Design Features and Technology Uncertainties for the Next Generation Nuclear Plant

Independent Technology Review Group

June 30, 2004

Figure 1. Schematic illustrating the level of risk as the degree of materials development complexity increases.

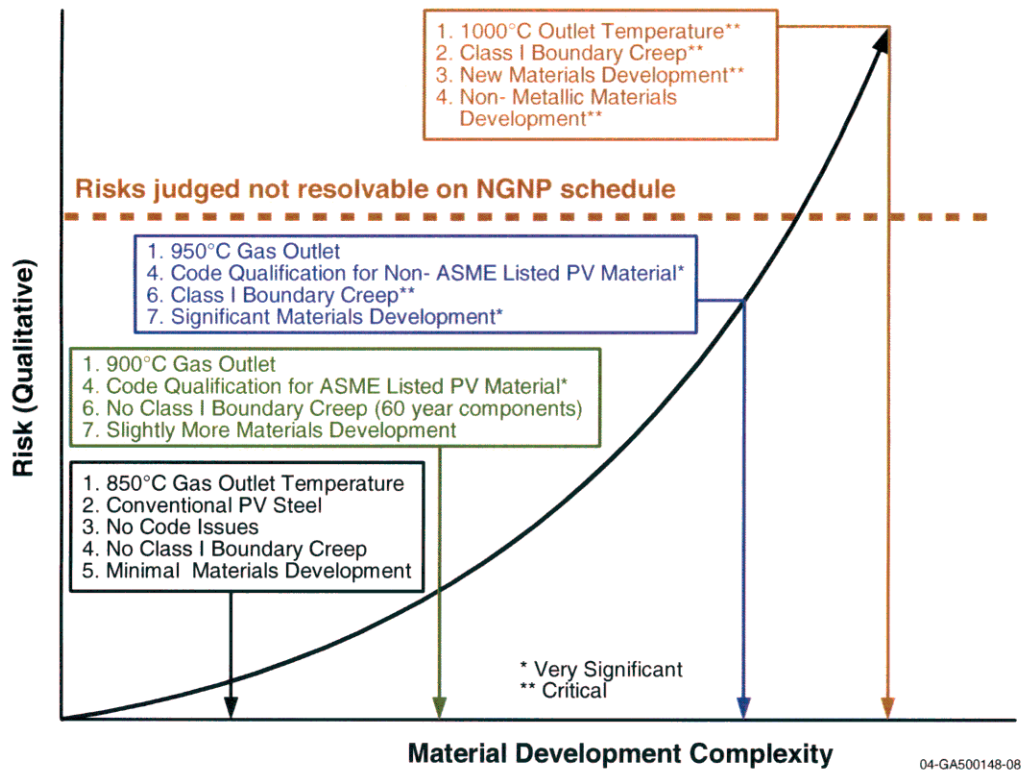
Figure 1 shows the degree of risk as a function of materials-development-related “complexity.” By increasing complexity we mean that the materials problem gradually becomes more significant with interdependent issues as the gas outlet temperature increases.

By far the most significant risk with respect to materials is associated with the requirement for a gas outlet temperature of 1000 °C or higher. Operation at 1000 °C may eliminate the indirect cycle and hydrogen generation at this temperature. This requirement essentially eliminates metallic materials for an NGNP on the construction schedule identified. The high temperature would also greatly aggravate the risks associated with ASME code qualification, welding, and processing, and essentially all of the other risk factors identified. As a result of this, it is our judgment that a gas outlet temperature of 1000 °C or higher represents a significant risk for successful completion of NGNP on the specified schedule. A more realistic, achievable, maximum temperature of 900 °C for metallic components was arrived at by general consensus.

The next most significant risk factor is that associated with the allowance of creep deformation in the Class I pressure boundary. The high gas outlet temperatures anticipated for the NGNP require use of materials for the pressure boundary that are at least capable of operating at temperatures above those of current pressurized water reactors, an attractive option from a plant efficiency point of view. However, while some (very few) of the current pressure vessel materials are capable of higher temperatures, operating at metal temperatures and stresses where creep or creep-fatigue mechanisms are significant represents a very substantial departure from current practice. The allowance in the design for creep during operations will also result in a very significant increase in the R&D costs, as well as the required component inspection and monitoring. The judgment of the ITRG is that, while operating in the creep regime is possible, the achievement of this goal on the time frame of the NGNP will not be practical. The ITRG therefore recommends that creep deformation not be allowed to be significant for irreplaceable (60-year life) components that are a part of the Class I boundary, such as the pressure vessel and primary system piping. For Class I components that could be replaced on a more frequent interval, such as the IHX, creep deformation may be allowed but at the expense of significant real-time monitoring and inspection.

Figure 3. Direct cycle power conversion unit with helium main heat transfer loop.

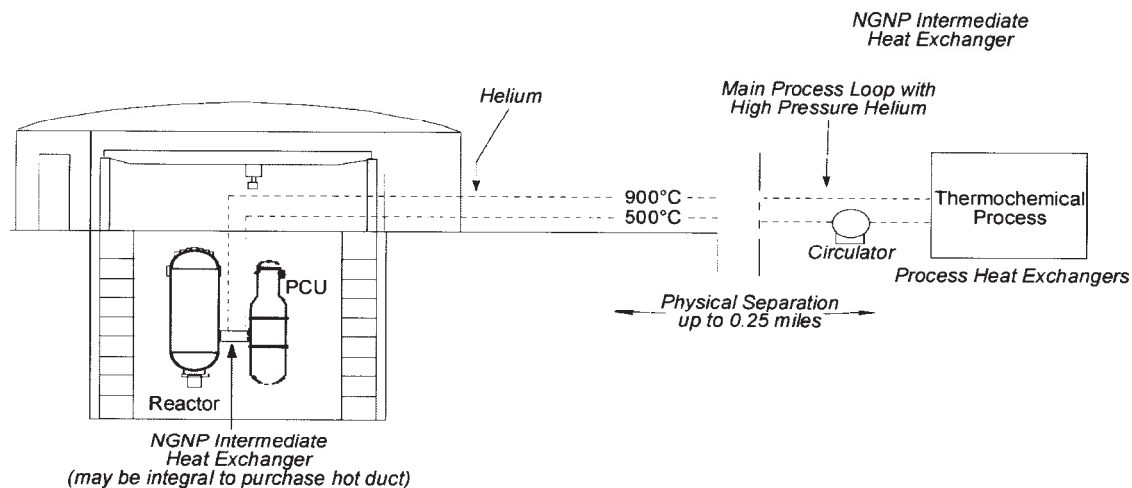
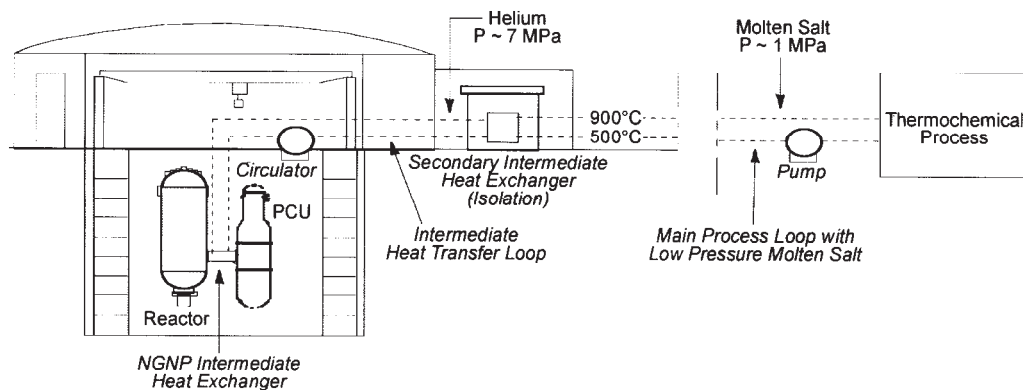
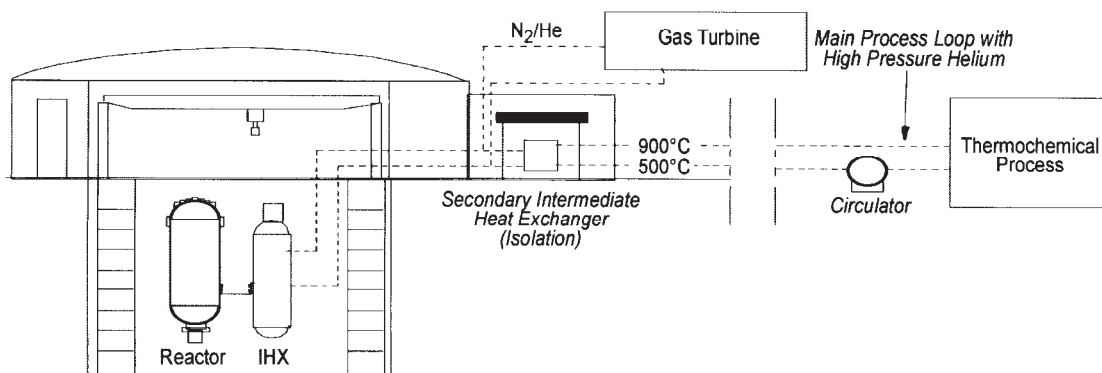
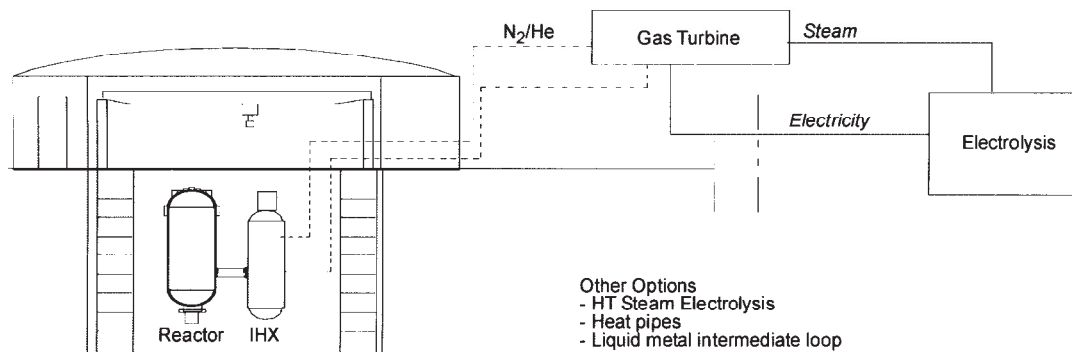
Technical Justification. The designs and materials of construction of the NGNP IHX, any secondary IHXs used in the system, hot gas ducts, molten salt loops (if used), and the process plant heat exchangers (see Figures 3 through 6), have yet to be determined. All of the heat exchangers must exhibit high specific heat transfer area (up to 1000 m²/m³) and be able to operate at temperatures as high as 1000 °C. Candidate designs include the Heatric Printed Circuit Heat Exchangers (PCHEs), plate-fin devices, prime surface recuperator-type designs, and possibly C-C composite strip fin designs. Testing of PCHEs is being pursued by at least one vendor for helium-helium service. Use of helical shell and tube designs for helium-helium service applications may be possible, but the surface-area-per-unit-volume goals are unlikely to be met (HTTR uses such a design fabricated from Hastelloy XR). Other open issues include whether heat exchangers of the size required can be manufactured and how they would be inspected, serviced, and cleaned/decontaminated over the life of the plant. The specific Code requirements and Class 1 to Class 2 boundaries for the IHX are also not clear. Some needs may also exist for establishing accurate heat transfer data such as heat transfer coefficients. The JAERI Helium Engineering Demonstration Loop (HENDEL) operated in the early to mid 1990s to evaluate He heat transfer performance at up to 1000 °C. Data from this loop may contribute to the design of the IHX by providing experimentally determined heat transfer coefficients. Experience from HTTR is also likely to be valuable. Other valuable experience that should be factored into the NGNP development effort was obtained in Germany in the 1980s through the early 1990s. Research expenditures associated with the design of a process heat plant were reported to have been about \$2 billion. These efforts included testing of hot gas ducts and various heat exchanger designs.

- At this time, consider both helium and molten salt as potential candidates for the heat transfer medium between NGNP and the hydrogen production plant.

- Consider use of an intermediate heat transfer loop between the NGNP and the hydrogen production plant that will provide for additional isolation of the two plants.

- Consider use of two boundaries between the nuclear plant and the hydrogen production facility. In this arrangement, an intermediate helium heat transfer loop at high pressure (greater than reactor system pressure) would be coupled to a second IHX that transfers heat to either a gas or molten salt loop. The gas or molten salt loop would be the primary method of energy transfer to the hydrogen production plant over long distances.

Figure 7. Key issues related to licensing NGNP with thermochemical hydrogen production.

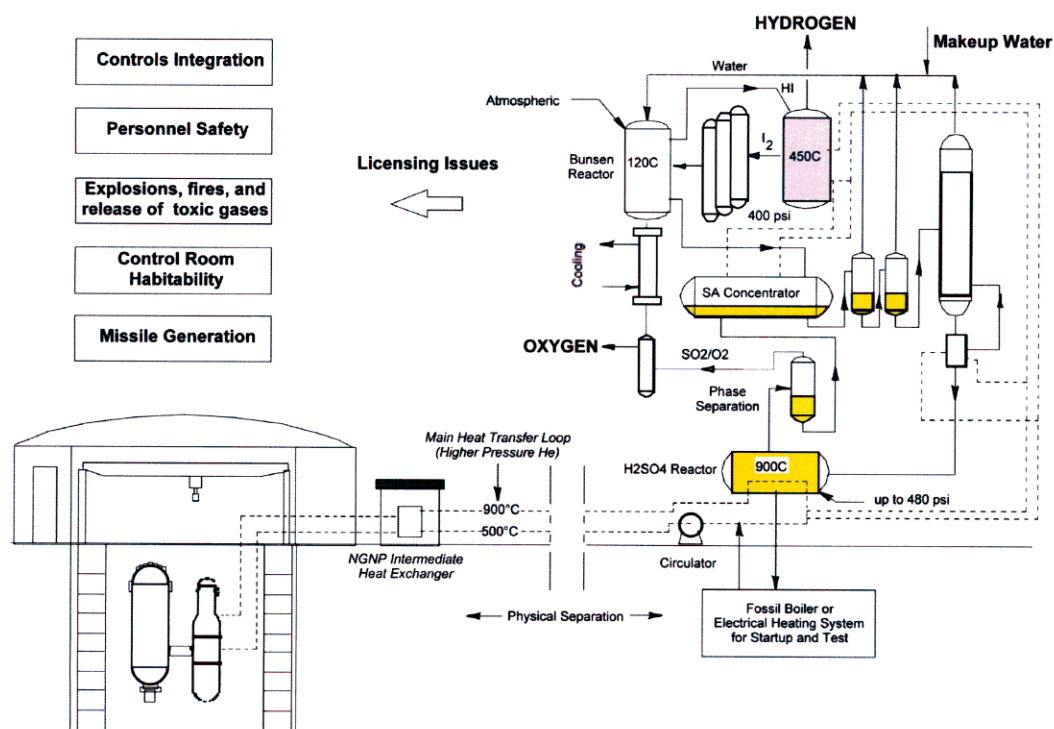
Technical Observation. Licensing of the NGNP will require evaluation of the potential for external events associated with the hydrogen plant, including (1) explosions, fires, and release of toxic gases, (2) control room habitability, and (3) missile generation. It is unclear that these issues have been addressed sufficiently to date, and therefore, they contribute to technical risk. Figure 7 illustrates the key issues related to licensing the NGNP with thermochemical hydrogen production.

Associated Risk. The primary risk is associated with an inability to license the NGNP because of unacceptable hazards posed by the hydrogen production facility. A secondary risk is that events at the hydrogen production facility could damage NGNP structures, systems, or components, corresponding to an investment risk.
